Re: CPV Sentinel Energy Project: Docket No. 07-AFC-3

Project Design Refinements

Application for Certification (07-AFC-3) for CPV Sentinel Energy Project Riverside County, California

FIGURE 2.4-1 (REVISED)

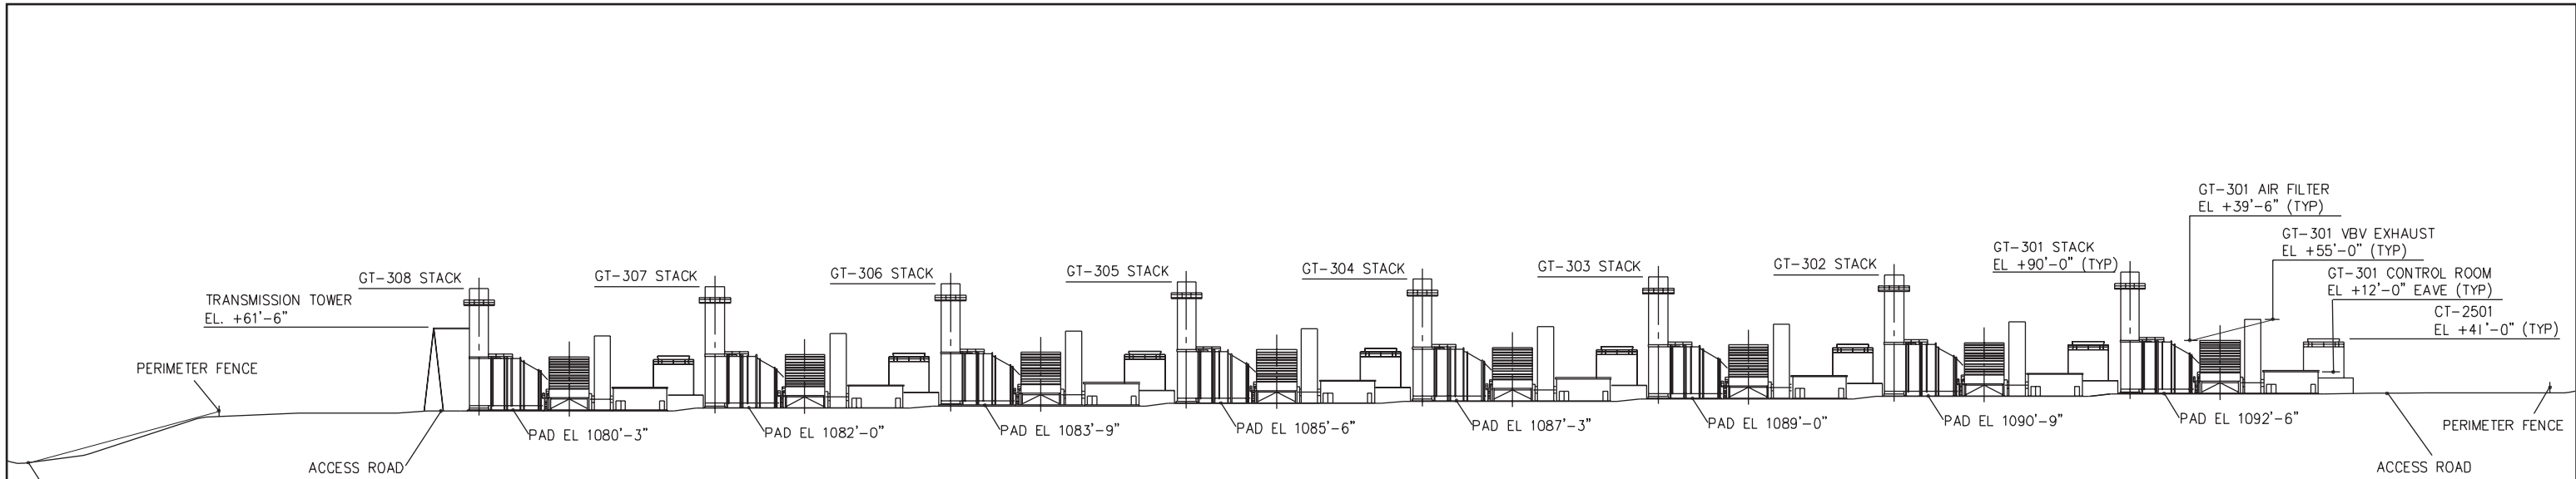
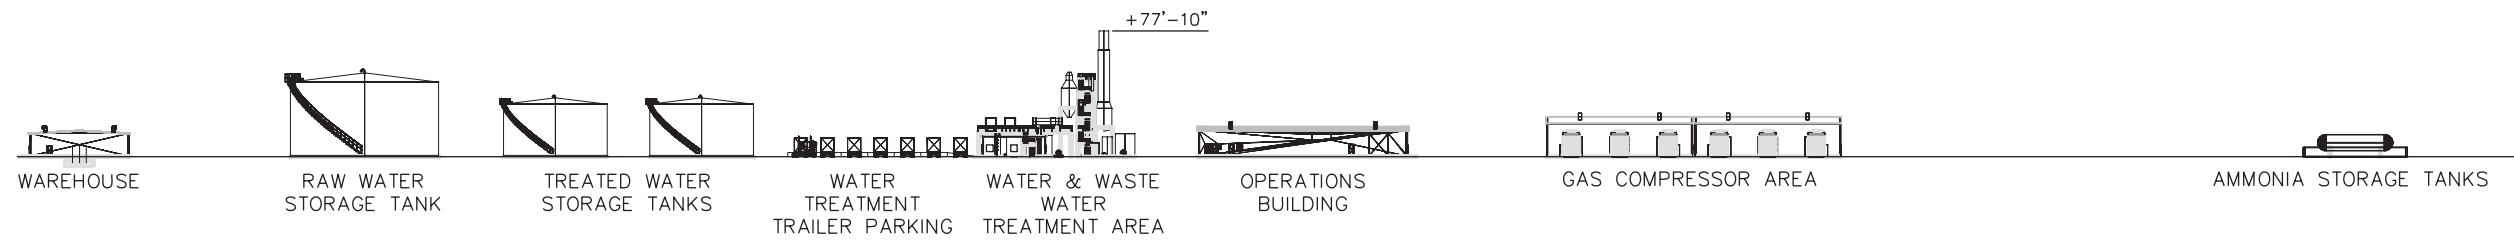
Refinements to the general arrangement presented in the AFC are listed below. These refinements are all within the 37-acre project site and do not result in any additional disturbed areas beyond the site not previously evaluated. Revised Tables 2.4-1 and 2.4-2 show the changes to the major structure heights and dimensions. Revised Figures 2.4-1, 2.4-2, and 2.4-3 show the new plot plan and elevation drawings.

- Renumbering Units 1 through 8 from south to north (rather than north to south, as presented in the AFC);
- The 3-cell and 5-cell cooling towers identified in the AFC at the southern and northern ends of the plant area, respectively, will be replaced with single-cell cooling towers located next to each turbine unit (eight total cooling towers);

- The three fire water pumps and associated enclosure will be relocated;
- A gas metering station, anode bed, and conduit will be added at the southeastern section of the project site;

- The septic system will be relocated further north to accommodate the gas metering station;
- One electric gas compressor will be deleted, and the six remaining gas compressors will be relocated to the eastern side of the plant, within a sound wall enclosure rather than a building;

- One of the two raw water tanks will be deleted and the remaining water tank and fire protection pump skid will be relocated to the southeastern portion of the plant site;

- The warehouse building previously located on the northern portion of the site will be deleted and the warehouse building that was located to the south of the switchyard area will be relocated further east;
- The oily water separator and drain sump will be relocated further west within the project site;
- The internal plant road will be relocated to the eastern side of the project site;
- The switchgear building and auxiliary power transformers will be relocated from between Unit 3 and Unit 4 to between Unit 4 and Unit 5; and
- The treated water storage tanks, water pumping skids, and water treatment trailer parking will be relocated to the southeast end of the plant site north of the raw water storage tank.

FIGURE 7.1-5 (REVISED)

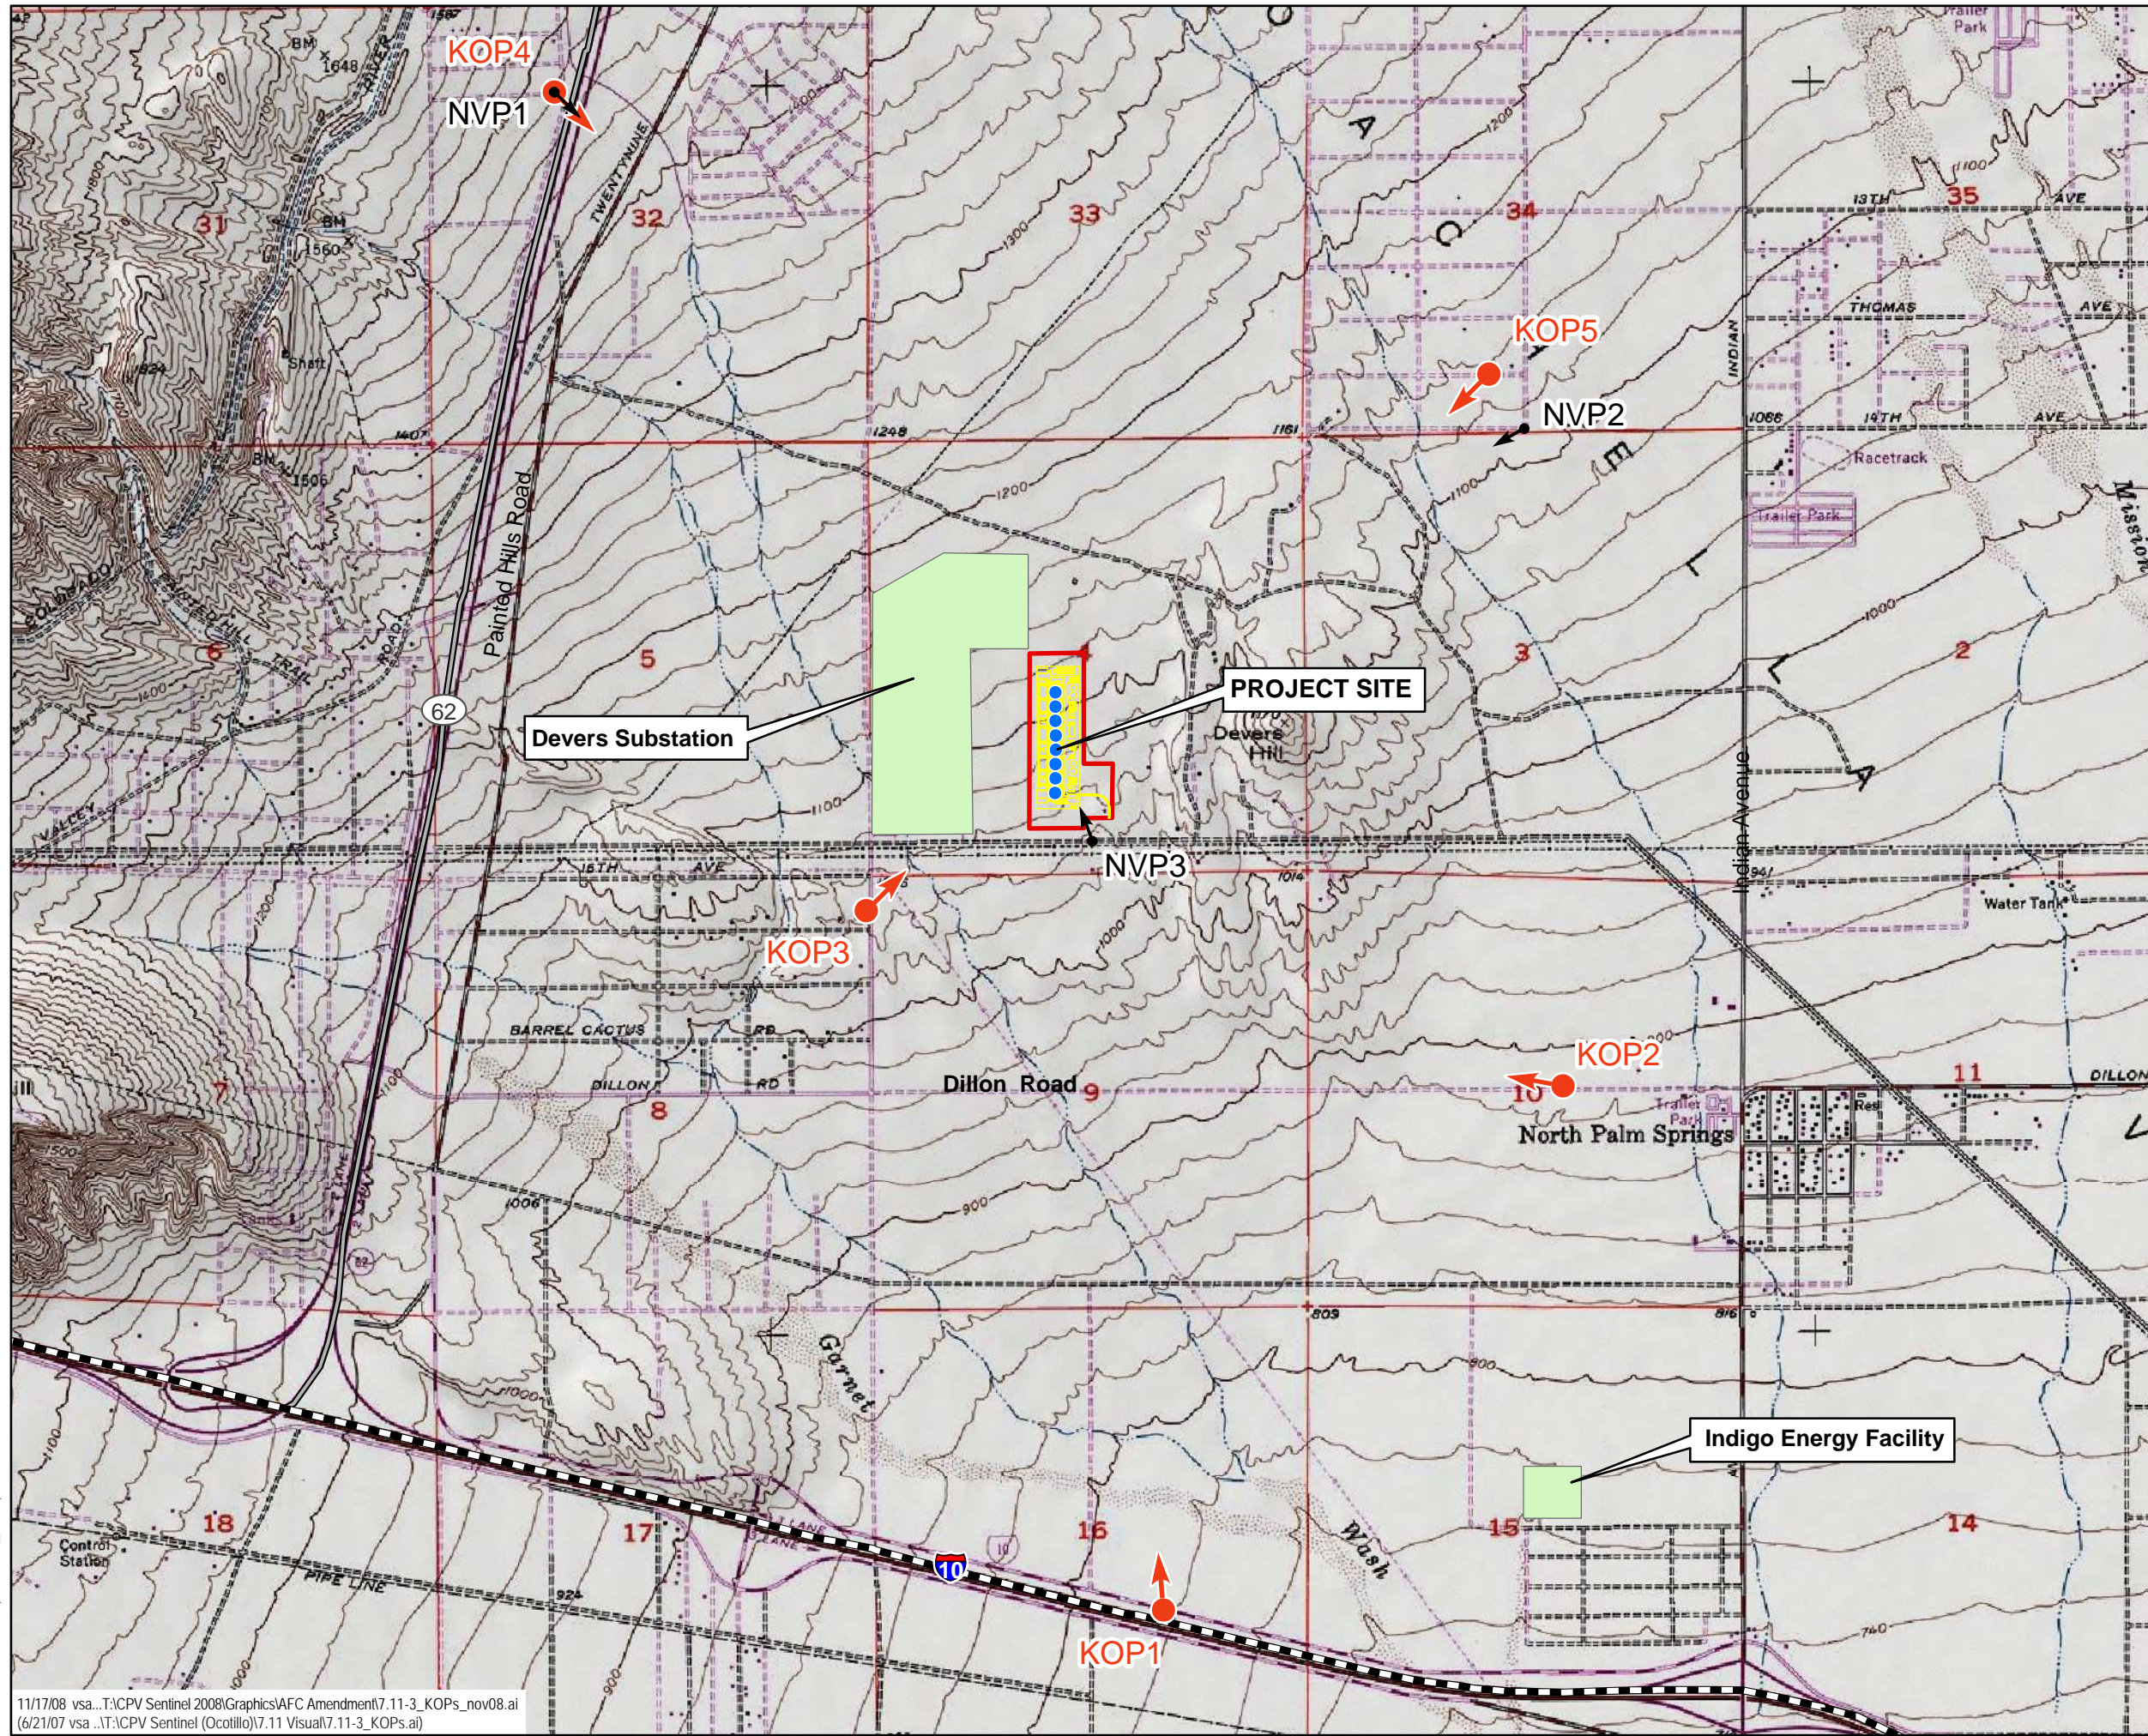
corner of the facility property line. Maximum 24-hour PM₁₀ and 8-hour CO impacts are predicted to occur approximately 450 meters south of the CPVS in line with the CTGs. Revised Figure 7.1-5 shows the locations of the maximum predicted operational impacts for all pollutants and averaging times.

FIGURE 7.11-9 (REVISED)

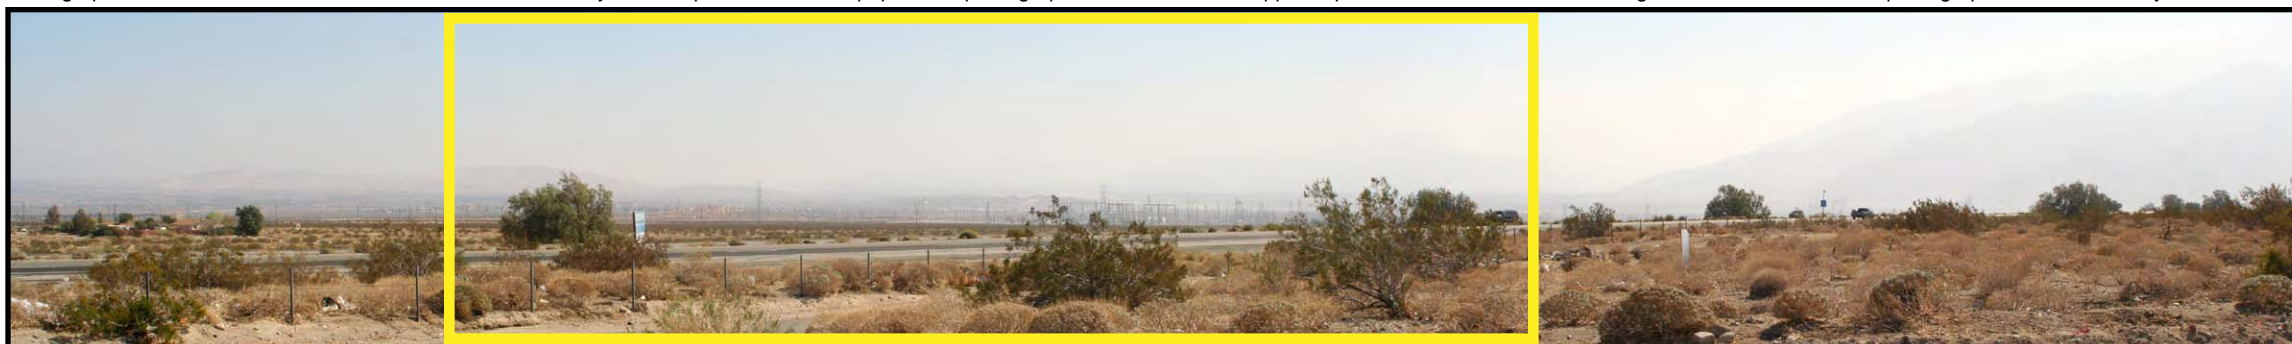
KOP 3 – The photo simulation shown in Figure 7.11-9 (Revised) illustrates the amendments to the proposed project. In the revised simulation, the 3-cell cooling tower located on the southern end of the project site has been removed and replaced with single-cell cooling tower units located adjacent to each of the eight generating units. The 5-cell cooling tower located at the north end of the project has also been removed but is not visible from KOP 3. Aboveground storage tanks previously not visible on the south end of the project are now visible in the amended simulation. The amended project will be seen through the transmission corridor and the SCE Devers substation. The most prominent items are a number of the eight CTG stacks. The cooling towers, once prominent features, now provide partial screening of the more geometrically complex generating units. The CTG stacks and other elements of the project are lower than the adjacent transmission facilities, but are more solid and structural in appearance. The transmission line from the proposed project to the substation is shown, but the towers are not distinct in the context of the existing towers. While the CPVS is discernable, its forms are subordinate to the adjacent wind turbines, there is no view impairment, and the level of visual contrast is low. Overall, the modifications of the CPVS would have a less-than-significant impact on viewers from KOP 3 consistent with the findings of the AFC.
